Engineering Change Notice

Model: IDK-1115WP-45FHA2

Purpose: Current PCAP EOL

Comparison:

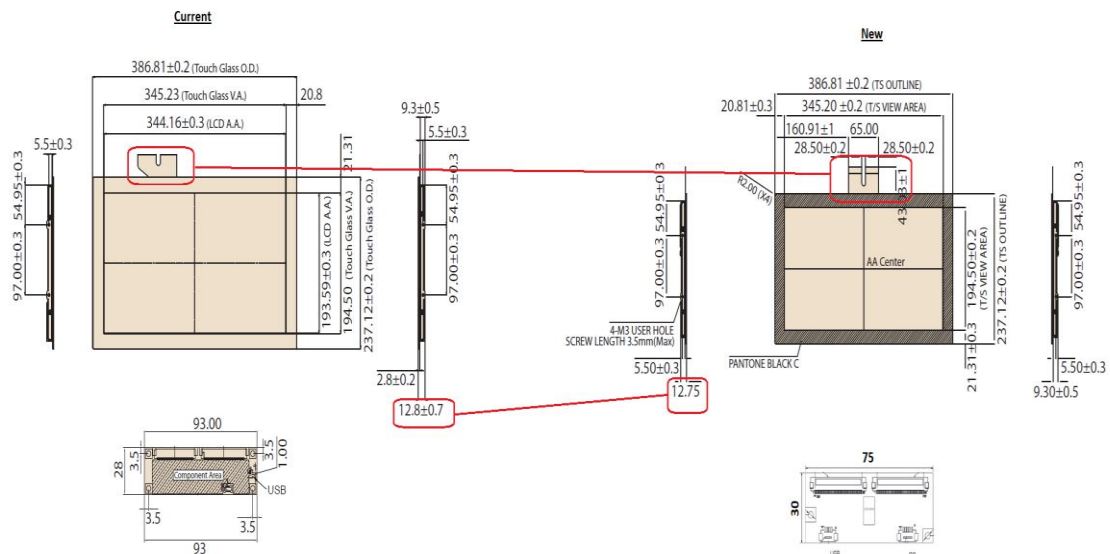
1. PCAP Cover Lens keeps the same
2. Touch sensor change from Glass sensor to Film sensor, so the thickness are different.
3. Touch control board change.
 - Touch control IC change from EXC80H84 to EXC80H60.
 - Touch control board USB connectors are different.

1. Keep the same PN: IDK-1115WP-45FHA2
2. Last time buy: NA, running change
